Application for Permission under Section 16 of the Town Planning Ordinance (Cap. 131) for Proposed Temporary Centralised Quarters for Imported Labour in Construction Sector for a Period of 3 Years in "Industrial" Zone and Area Shown as 'Road' of Planning Area 36 of Hung Shui Kiu/ Ha Tsuen New Development Area (Planning Application No. A/HSK/628)

Submission of Further Information

We refer to the comments received from various Government departments and the public between 4 September and 16 September 2026 regarding the captioned s.16 Planning Application.

No.	Comments	Responses
1.	Public Comments dated 10 September 2026 The public has expressed concerns in relation to the following aspects: - Long-term planning intention and development potential of the Site - Open Space Provision - Transportation Arrangements	With the gradual recovery of the economy and real estate market, together with the anticipated growth in public works projects, including the Northern Metropolis development, the demand for construction manpower remains strong in the coming years. In support of the Government’s Labour Importation Scheme, the proposed development will be essential to support the manpower requ

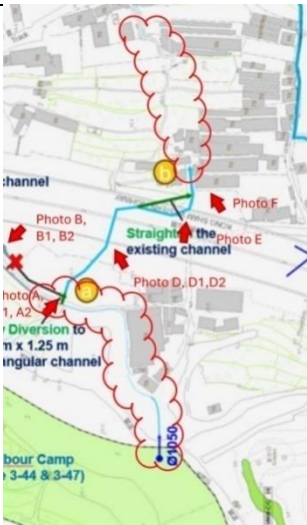
2.	Drainage Services Department, Operations & Maintenance Branch, Mainland North Division, Yuen Long Section, dated 04 September 2026 <u>Comments on DIA</u> (a) Referring to RtC Item 4(h), please provide site photos to demonstrate the presence and existing condition of said discharge path, as clouded in red in the following extracted figures.  <i>extracted figure 1 – discharge path at north of the site</i>	The site photos showing the presence and existing condition of the concerned discharge path has been supplemented. Please also refer to Appendix B of this Further Information for the revised Drainage Impact Assessment (DIA).

No.	Comments	Responses
	 <i>extracted figure 2 – discharge path at South of the site</i> (b) The proposed drainage scheme, calculation and other relevant information, including Annex 1 to Annex 4 in RtC should be included in the DIA. <u>Other Comments</u> Should the Town Planning Board consider that the application is acceptable from the planning point of view, I would suggest that a condition should be stipulated in the approval letter requiring the applicant to submit a drainage proposal (including revised drainage impact assessment to demonstrate that the proposed use of the site would not have adverse drainage impacts on the drainage issue to the area), to implement and maintain the proposed drainage facilities to the satisfaction of this Division.	Annex 1 to Annex 4 have been supplemented in the revised DIA. Noted.
